Point No. 1: It was considered that carrying out the activities just about 8 to 10 meters of the HTL may need a proper handling of Pollutants. The project proponents were advised to give a list of all wastes anticipated, classification of the waste as per their inclusion in various categories under the Pollution Control and Environment protection laws and the mode of disposal.

Point No. 2: Give proper details of handling Asbestos in the open and within rooms.

Location map on Google Image

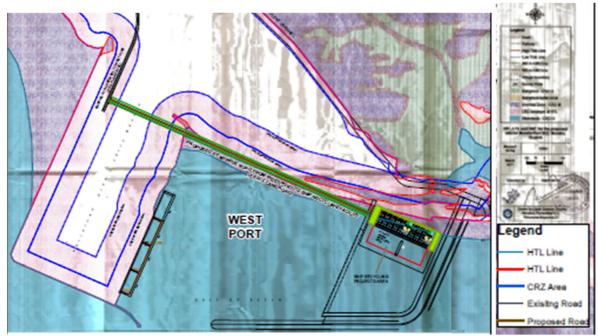
Comment No. 1

Out first comment was "The exact status of the land required for the project may please be clarified – how much of it is within the intertidal zone, and how much of it is submerged. As per figure 2.1, it seems the entire site is in the intertidal zone." The reply is incomplete except for providing the information that the project area is located on the eastern side of the west port which is part of Waterfront Development Project for which MoEF has granted approval in 2009 and that it includes creating port back up areas (reclamation) using dredged material. It further says that the project area is partly in the intertidal area and mostly submerged area which is to be reclaimed as per Environmental and CRZ clearance granted by MoEF as mentioned above. It is pertinent to point out here that a report of the Committee for inspection of M/s. Adani Port and SEZ Ltd., Mundra, Gujarat, April 2013, headed by Sunita Narain under mentions that "the Adani Waterfront and Power Plant project, which has been granted clearance in different phases beginning 1995, has led to massive ecological changes with adverse impacts." Also, no clarification was given in terms of the area as acquired in the intertidal and how much is submerged area which has been reclaimed.

APSEZ response:

The proposed ship recycling facility will be developed over an area of 40.7432 ha. It is located on the eastern side of west port which is being developed as part of Water Front Development Plan and granted Environmental Clearance vide MoEF order dated 12.1.2009 & addendum dated. 19.1.2009 (copy enclosed as **Annexure – 1**) and validity is further extended up to 11.01.2019 vide MoEF order dated 07.10.2015 (copy enclosed as **Annexure – 2**). The reclamation of the west port area (920 ha) is permissible activity as part of approval under the EC for WFDP to facilitate the backup infrastructure activities. The status of project area as per CRZ map was submitted along with EIA at relevant time during the process of obtaining Environment & CRZ clearance. Presently land is reclaimed. Refer following Google Earth Image of Mundra West Port area with the project site marked.

As evident from the report of committee appointed by MoEF, there are no adverse comments with respect to proposed project location.
